REVISED PROPOSAL FOR DRAFT 04 SERIES OF AMENDMENTS TO
REGULATION No.44
(CHILD RESTRAINT SYSTEMS)

Transmitted by the French Delegation

This amendment has been prepared to introduce in Regulation n°44 the new anchorage system standard for child restraint systems (CRS) prepared by the International Organization for Standardization (ISO).

Fig 0a (delete)

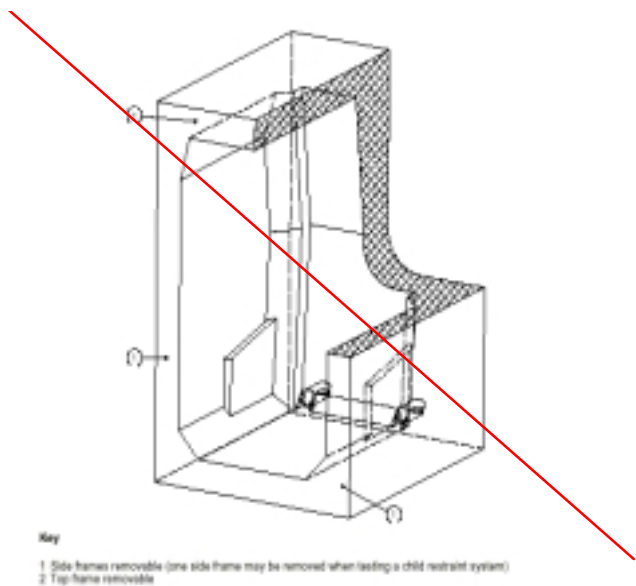
“2.31. Vehicle seat fixture (VSF) means a fixture, complying to dimensions shown in figures 1 and 2 of annex 7 appendix 2 of ECE Regulation N°16 0a and 0b, used by a child restraint manufacturer to determine the appropriate dimensions of an ISOFIX child restraint system and the location of its ISOFIX attachments .”

Fig; 0b (delete)

Figure 0c Dimensions in mm

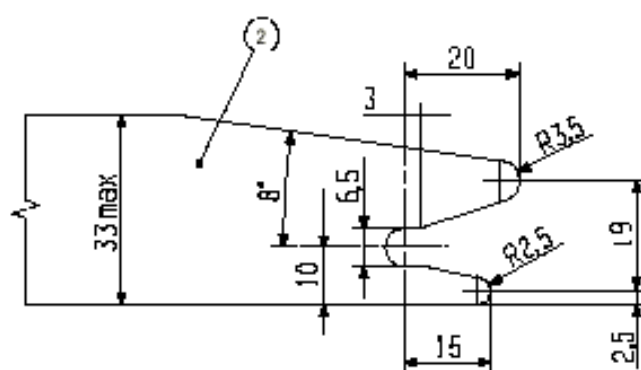
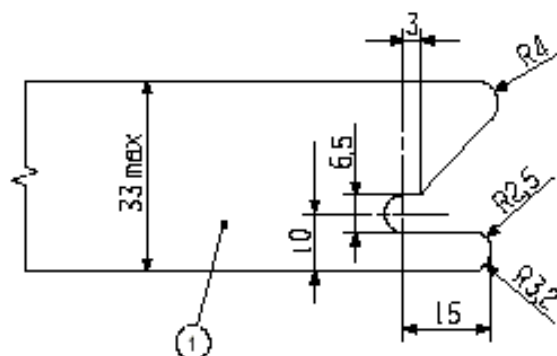
Attachments to anchorages may be according to examples shown in Figure 0c, or other appropriate designs that are part of a rigid mechanism having provision for adjustment, the nature of which is determined by the child restraint system manufacturer.

Figures 0c and 0d have been inverted

Figure 0d Dimensions in mm

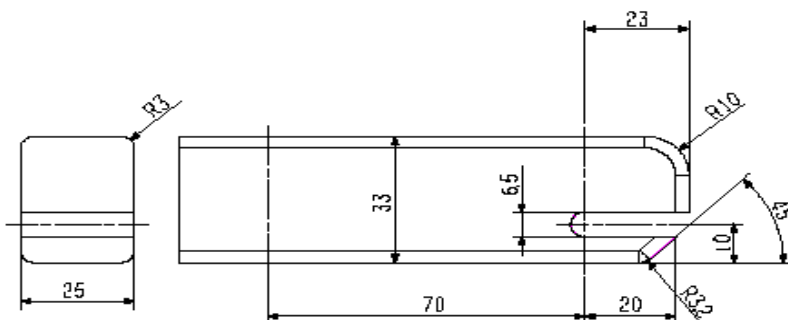
Dimensions for the portion of the ISOFIX child restraint system connector that engages the anchorage bar must not exceed the maximum dimensions given by the envelope in Figure 0d

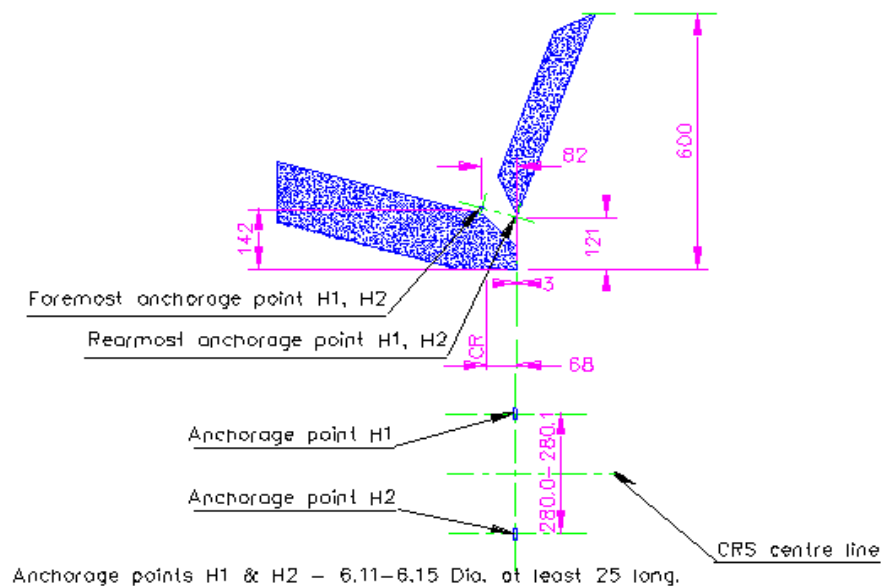
" **2.3. For child restraints using ISOFIX attachment, points H₁ and H₂.**

" 3. Anchorages A, B **and/or H₁ H₂** and D shall be used (... no change...) upper anchorage.

4. Anchorages A, B **and/or H₁ H₂**, E and F shall be used (... no change...) upper anchorages."

- Insert a third figure to see :

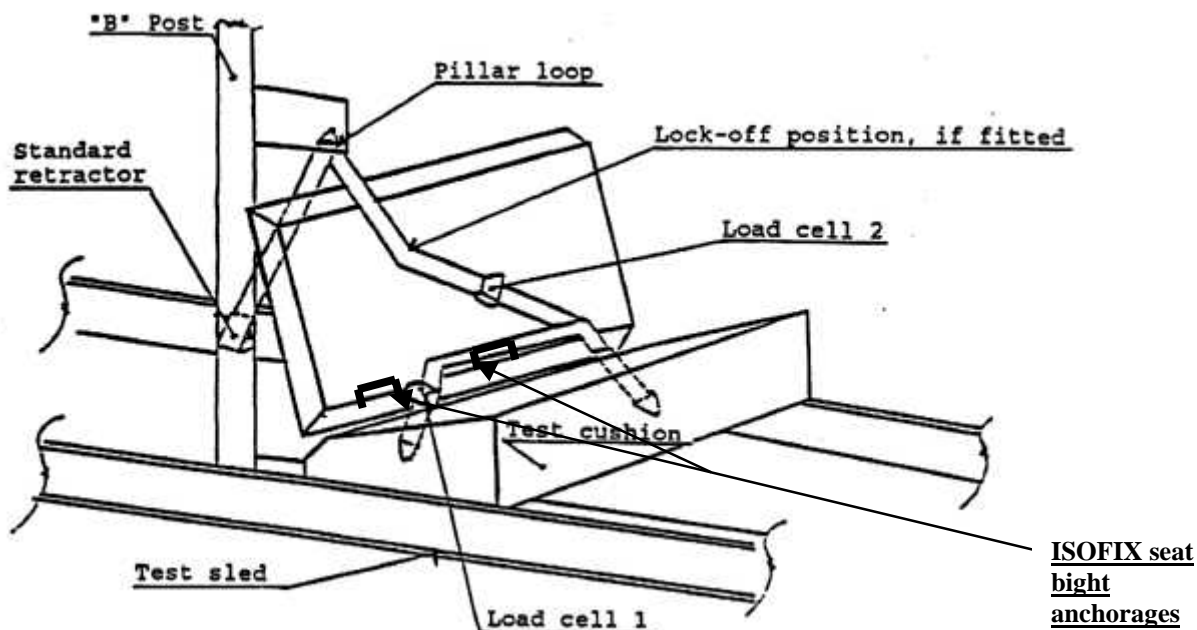
- In Annex 6. DESCRIPTION OF TROLLEY, appendix 3, amend paragraph 1 to read :
"1. The anchorages shall be positioned as shown in the figures **1,2 and 3** below."
